AIRWORTHINESS ADVICE NOTICE

TYPE AFFECTED: Jantar and Jantar Standard. All variants.

SUBJECT: Miscellaneous airworthiness information.

FIGURE 1. LOCKING WASHER SECURITY

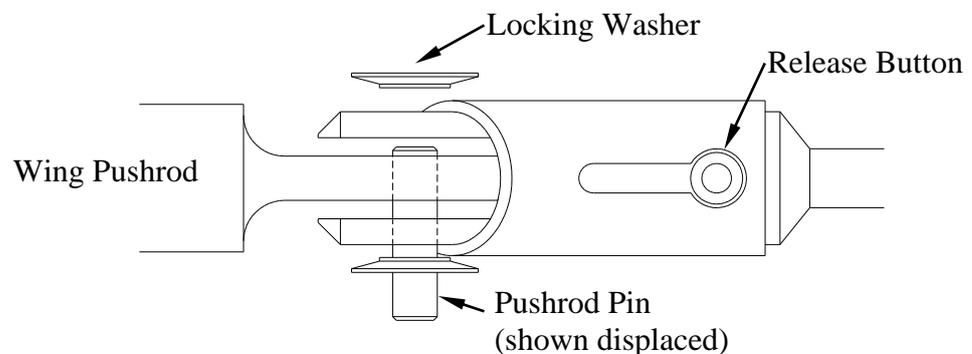
Experience has shown that the locking washer on the connecting pin in the elevator and/or aileron connectors may work loose allowing the control to be connected incorrectly as shown in fig. 1.

Should the locking washer be loose then the defect must be rectified before next flight.

The defect may be rectified by either replacing the washer with a new part (the best option) or by cold forming the washer until the hole is between 5.980 and 5.990 mm diameter.

Cold forming should be done by either pressing flat between plates or by placing a steel ball (~ 20 mm \varnothing) on the hole and then tapping with a hammer. If using the steel ball method the washer should be turned over and the process repeated.

Before pressing the washer on, the pin diameter should be checked for the correct size of 5.992 to 6.000 mm diameter.

FIGURE 2. POSSIBLE AIR BRAKE JAMMING

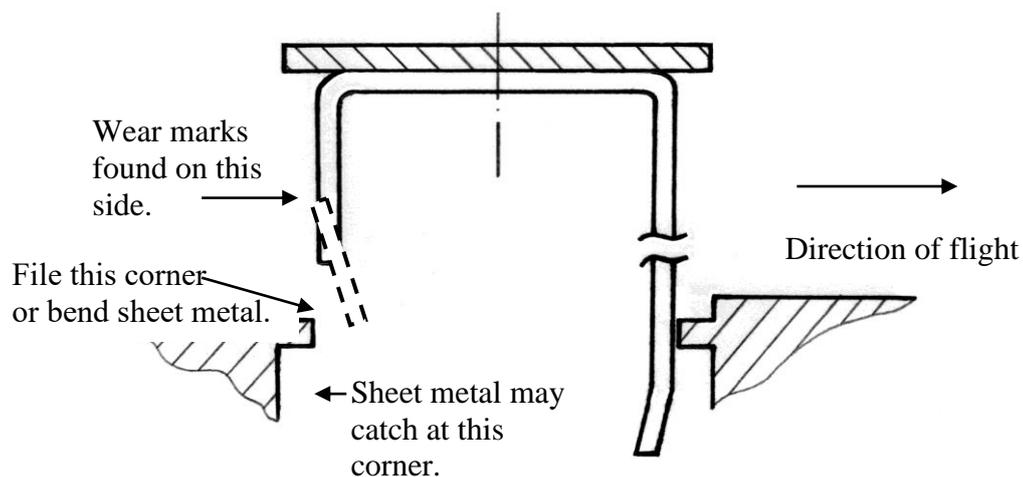
3. Scratch marks on the backside of the airbrakes were found on two Standard Jantars (1 and 3). With only little force it was possible to jam the airbrakes when they were extended. So far no incident has been reported but it is strongly recommended to check the airbrakes to prevent possible jamming and perform corrective actions if required (ie. Bevel (file) the corner or slightly bend the sheet metal). See figure 2.

Fig.1.

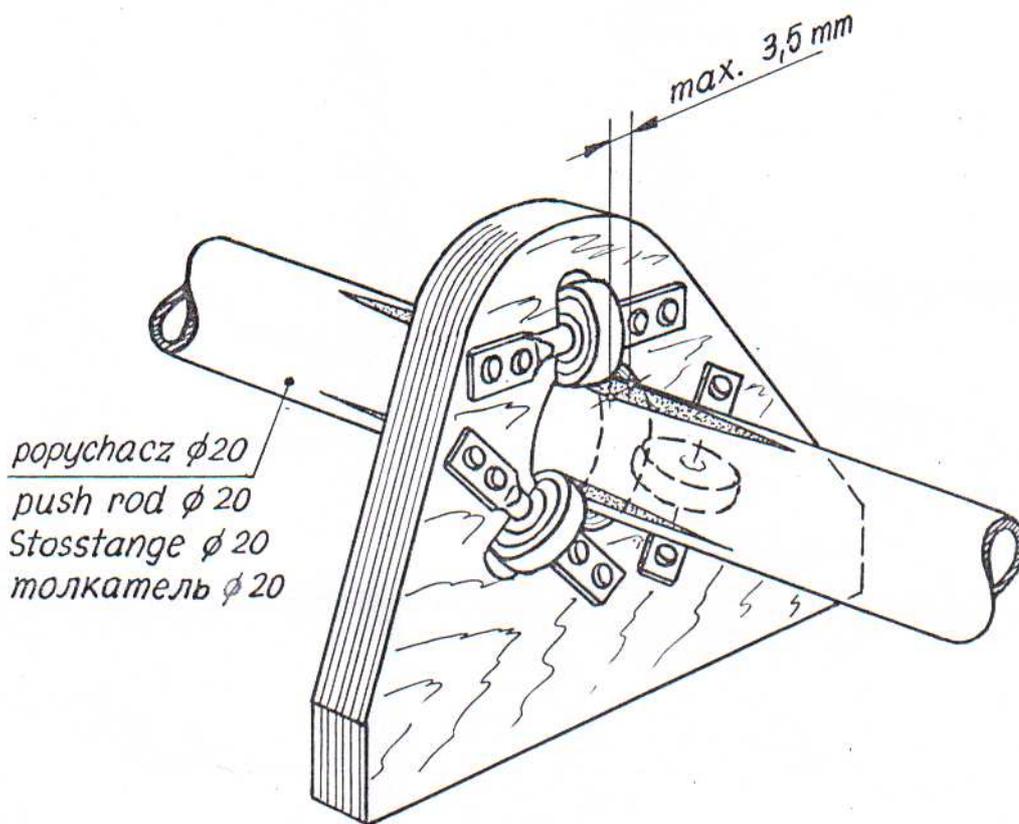
- 3.1. The allowed push-rod wear is defined.
- 3.2. When the allowed push-rod wear is exceeded the push-rod is allowed to be turned by 180° so that the contact takes place between the previous "wear surfaces".

- 5.1. The allowed limit width of the roller "trace" on the push-rod surface is 3,5 mm (Fig.1).
- 5.2. In case the allowed wear value is exceeded (even on one place-only) - disconnect the control system and turn the push-rod by 180°. Then secure it and check the adjustment.

Fig.1.

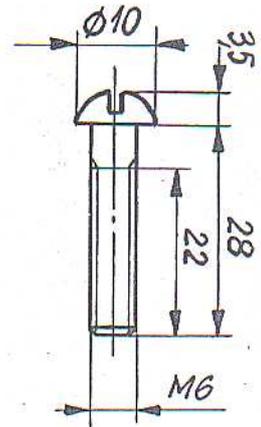
The additional securing of the bolt connecting the tailplane with the fin, providing the bolt is correctly installed, is got by the M6 screw /Fig.1/.

Fig.2.

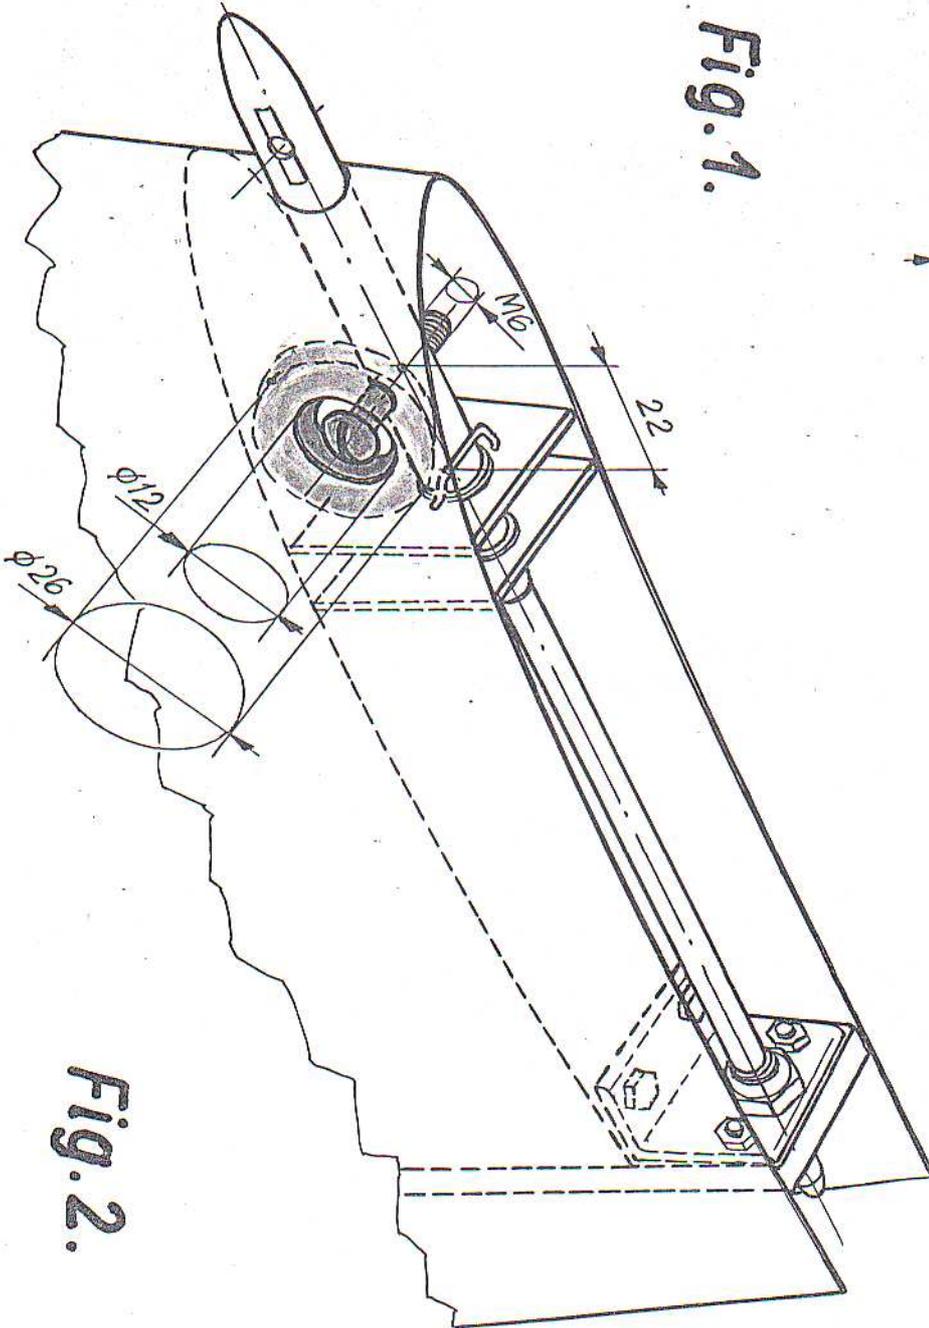
It is screwed into the bolt pivot, as shown on the sketch of Fig. 2 so that its head touches the external lap.

5.1. On the pivot of connecting bolt (44-40-00) the opening of $\varnothing 4,8$ (for M6 thread) should be traced and drilled through on the distance of 22 mm from the stop surface (in respect to the front nest sleeve face - see Fig.2). The opening axis should be parallel to the cuts for the locking spring. Smooth the opening edges.

- 5.2. After derrigging the tailplane insert the bolt (44-40-00) into the fin nests till the locking spring clicks. Using the \emptyset 4,8 hole trace the hole \emptyset 12 location on the fin left skin. Drill the preliminary opening (e.g. \emptyset ,8) and check it to be axial. Then enlarge it to \emptyset 12 or regain the axiality, if necessary, by means of fileing.
- 5.3. Make the M6 thread in the bolt.
- 5.4. Make the composite stop block in the from of the ring \emptyset 26/12 and 6 mm thick. Glue it in using the epoxy composition.
- 5.5. Check the correct securing with the screw. (taiplane derrigged). The srew head should contact the stop block.
- 5.6. On the glider ready for flight the bolt shall be secured with the M6 screw and the hole \emptyset 12 should be plugged with the \emptyset 25 ring of tixo-tape.
